Re: Objection-Redevelopment of Greenwich Hospital (Concept Proposal)SSD17-8699

Sewage overflow into Gore Creek 6 Jun 2016

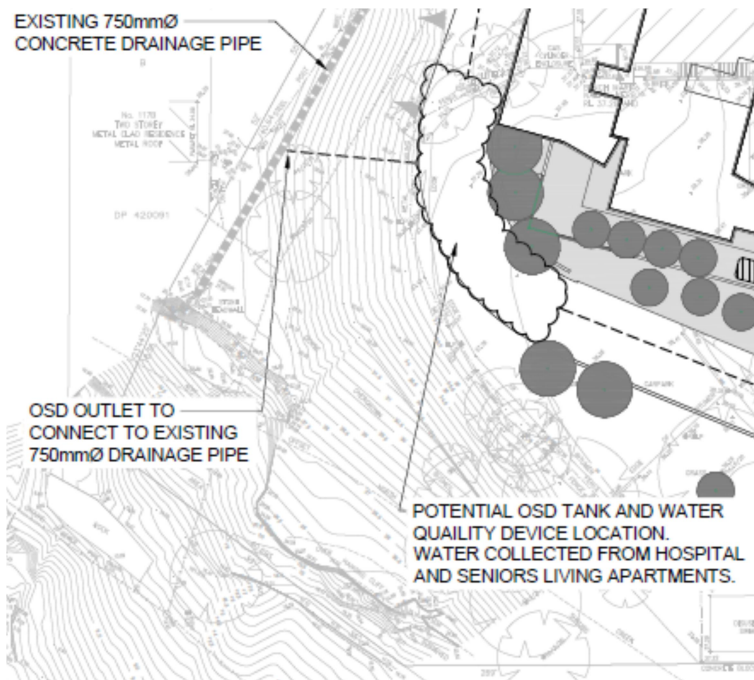
Sewer- There is an above-ground sewer main pipe line running just 10 m below, and generally parallel to, the south-west boundary of the subject site and crossing the cascades' path. Sewage from descending pipes serving presumably nearby houses and the Hospital site enter into the main. Risk of damage to this sewer main infrastructure due to uphill works, tree root invasion, 350% increase sewage inflow from rock falls, is real, and a costly, possibility. Even once damage to sewer and creek stone walls is repaired at community's cost, bushwalks were closed and areas remained for months, roped off by Sydney Water due to health hazards, and environmental damage to land and water lingers long, such as inappropriate nutrients and soil and rock mobilisation. Photos below show an incident of sewage overflow into Gore Creek on 6 June 2016; the resulting erosion and rock piles have still not been attended to.

Cascades into creek, after rain, from site

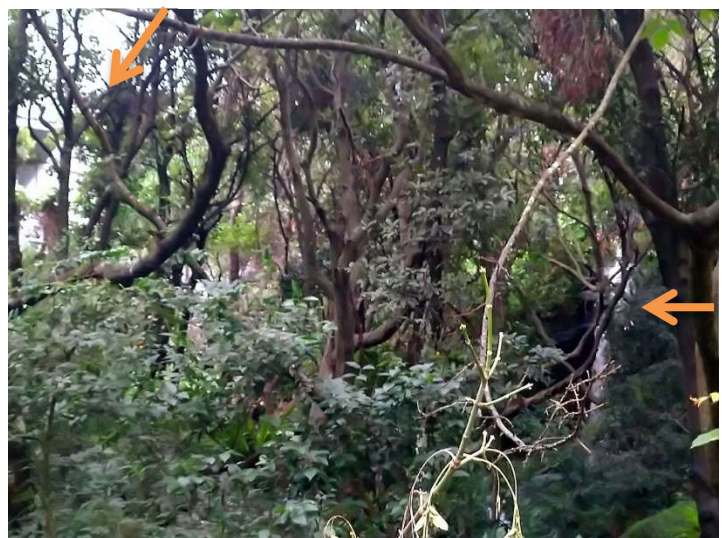
Below photos show the rock cascades below where the 750 diam pipe discharges, and the waterfall above formed by the discharge from the pipe.

Orange arrow(L) shows 119? River Rd; (R) shows waterfall

Image 07: Overlay showing protected vegetation (shaded green), minimum required APZ for new SFPP (red line) and BAL Low setback (pink line).

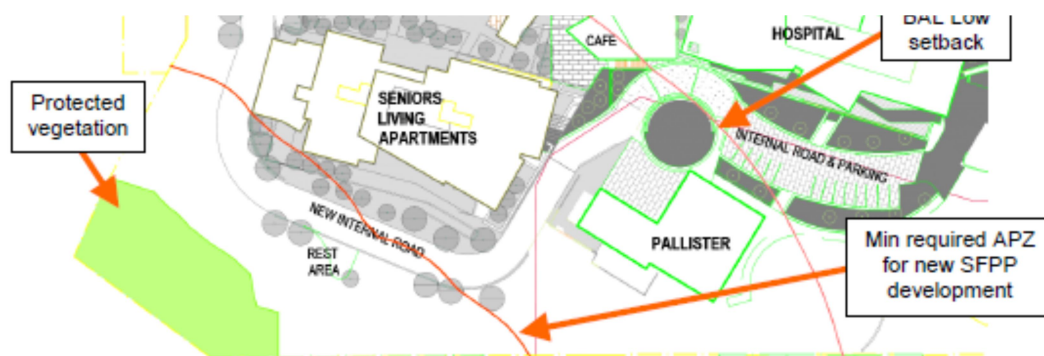
It is not clear in the diagram in bushfire, where is the “protected” vegetation, and what is intended for the vegetation which contains trees and shrubs below the internal road. Compare the Zone C with

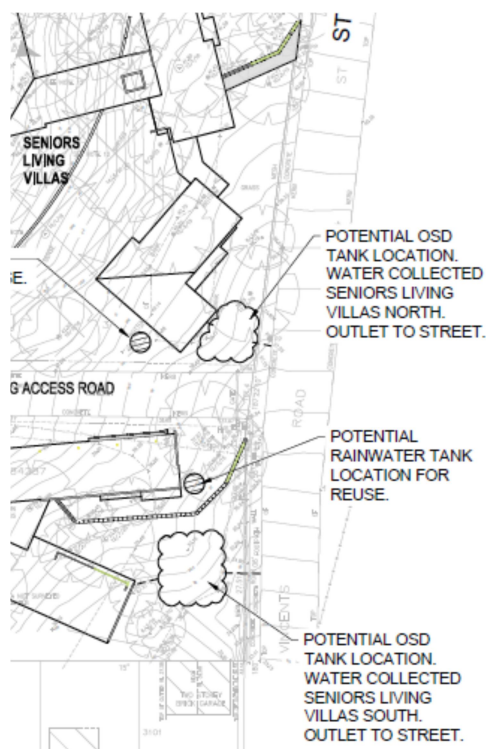
Page 18 of Heritage Assessment Report shows that the whole of the area of Pallister's Curtilage inside its Lot is gazetted under a Permanent State Heritage Conservation Order. HammondCare knew this when purchasing the land in 2008, yet now they seek to change it. Many trees are removed, the historic setting is destroyed, and retaining walls and OSD tanks are proposed in the Curtilage as shown on extract from Civil Plan, see below. The proposal is not consistent with the protection of the Curtilage as required
